**Re: Request for Council's Advice on SSD-64409468 – Western Sydney Airport
Business Park**

Attachment A – Detailed comments

Figure 5: Development encroachments on the riparian corridor and potential areas for offsetting

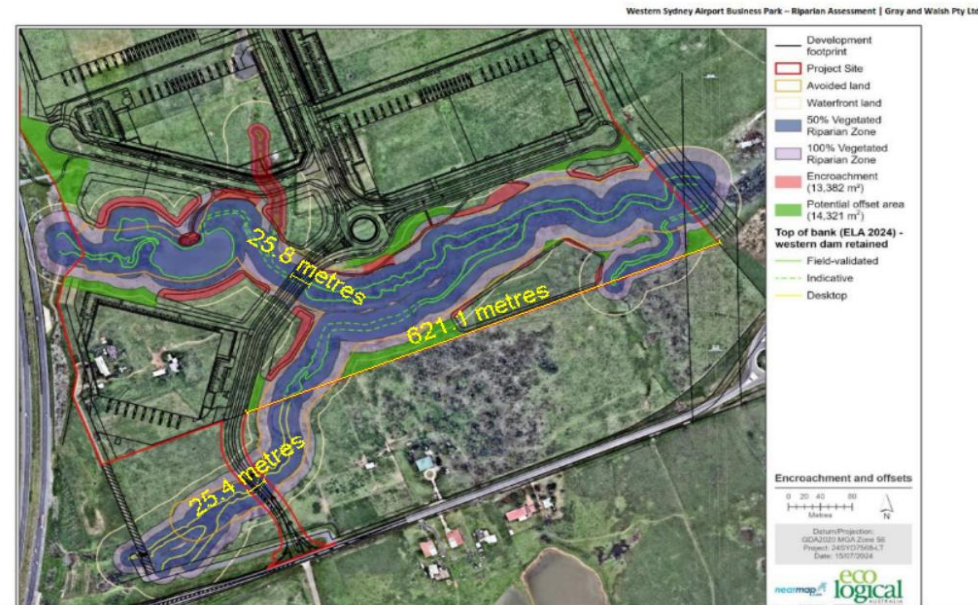
This outcome is not identified in the “Western Sydney Airport Business Park – Riparian Assessment” prepared by Eco Logical, Project No: 24SYD7568, Version 1, Dated 24 July 2024 as the mapping used is not consistent with the Civil Engineering plans, see comparison below:

The above map is not consistent with the civil design of the proposal shown on the “Erosion & Sediment Control Plan Stage 1,” Drawing No CO15092.00-SDA201, Issue A, dated 17.07.2024 (see excerpt below) in terms of either location or design. The above image is located approximately 18.8m to the west of where the Civil Plans identify the road works to take place. Additionally, the above image appears to show both waterway crossings to be bridged with a width roughly equating to the WSAPP and DCP road reserve width requirements for a collector road. The civil plans below show road works, associated batters and drainage works to encroach significantly into the riparian corridor, ENZ Zoned land and land mapped High Biodiversity Value under the SEPP.

The proposed civil plans are not supported and will require amendment. It is recommended that both the Cosgroves Creek road crossing and the southern tributary road crossing are provided by way of bridges. These bridges should be of a sufficient span and dimensions to permit pedestrian and active transport access along the line of the waterway in accordance with “Figure 9 Active Transport Network” of the WSAPP.

4.25 Preservation of trees and vegetation in Environment and Recreation Zone and Cumberland Plain and

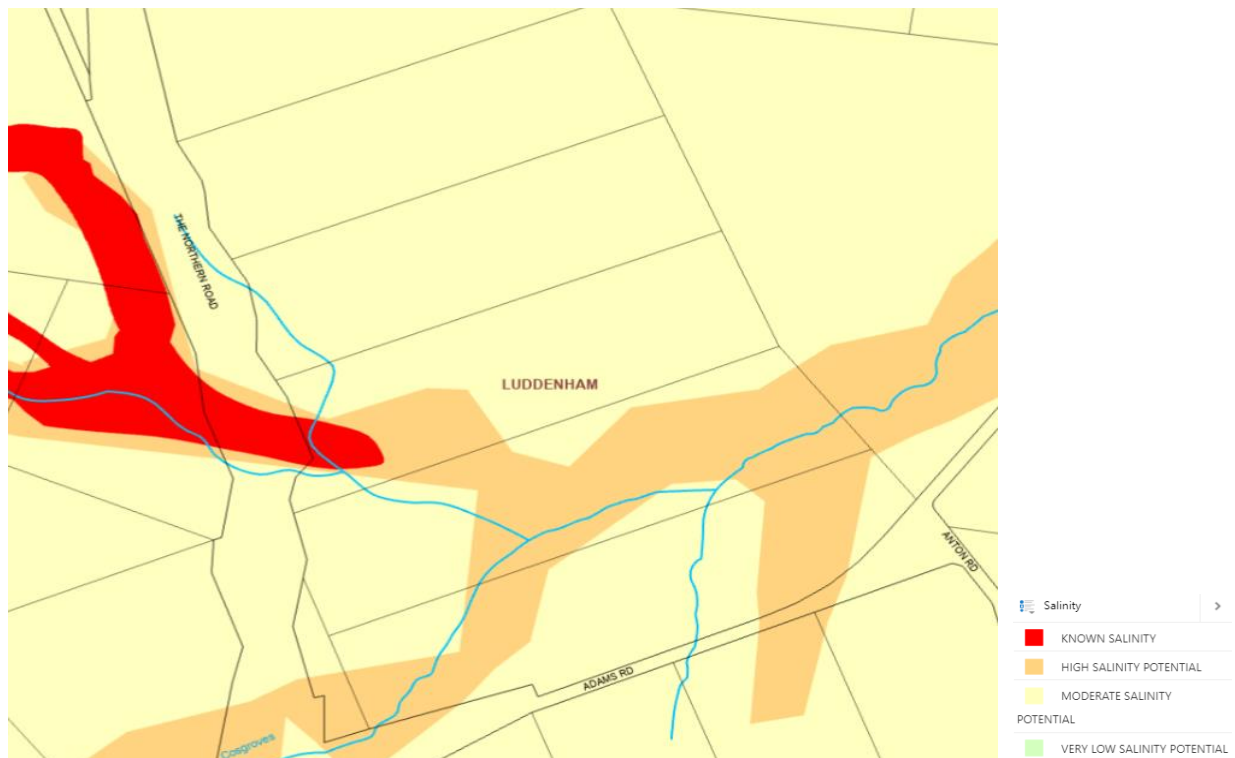
As discussed above, the proposal does not demonstrate compliance with these clauses of the SEPP as significant earthworks associated with road works are proposed within land mapped existing native vegetation under the High Biodiversity Value Areas Map and native vegetation is proposed to be removed.

Council recommends that extensive batters and fill are avoided, and that riparian land is spanned by appropriately designed bridges. This is a reasonable alternative to vegetation removal that will minimize any impacts on existing vegetation and the ENZ Zone.

Figure 12 - Roads Infrastructure

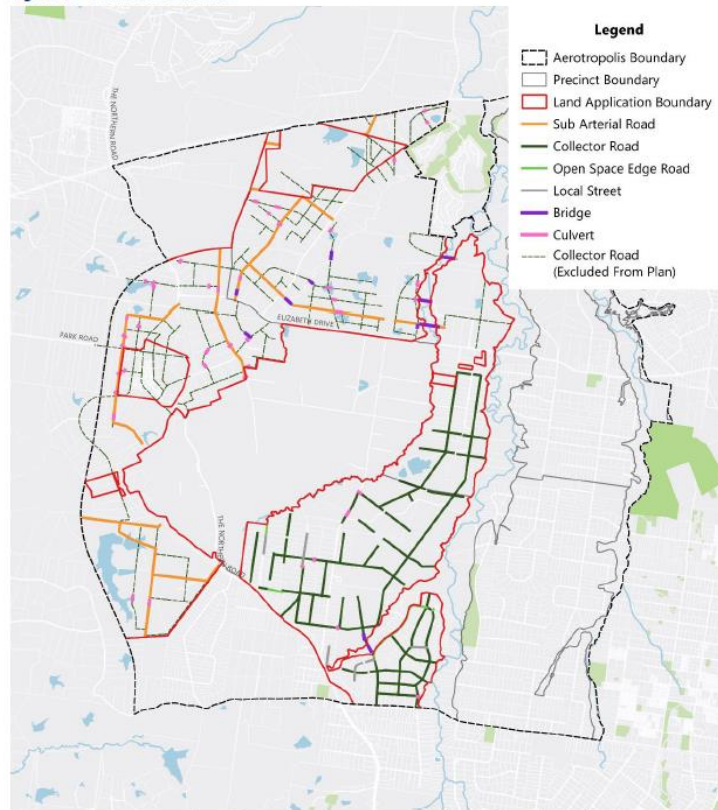
10) The subject site is affected by the proposed collector road as per 7.12 Council's aerotropolis precinct contribution plan. Confirmation is required with Council for design requirements of this proposed collector road and associated the road reserve.

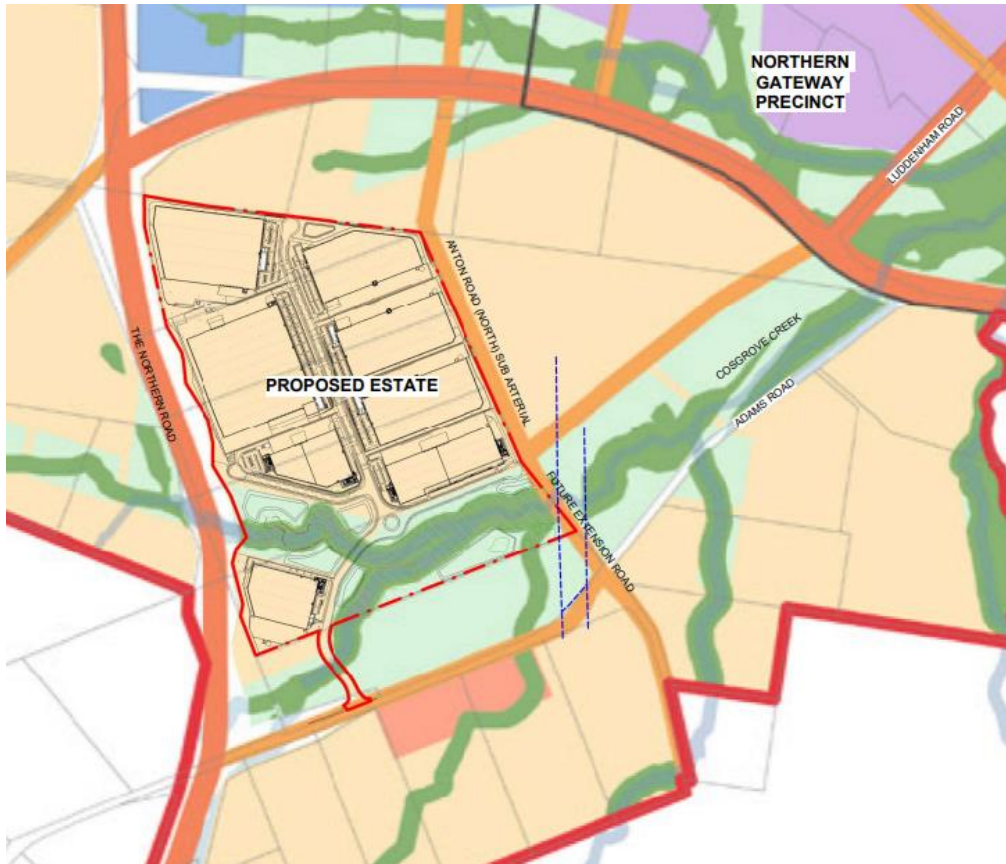
- 11) The subject site is affected by the planned sub-arterial road including the Anton Road extension and Luddenham Road. Road reservation is to be identified along these roads. The DPHI is to confirm the funding and delivery mechanism for these
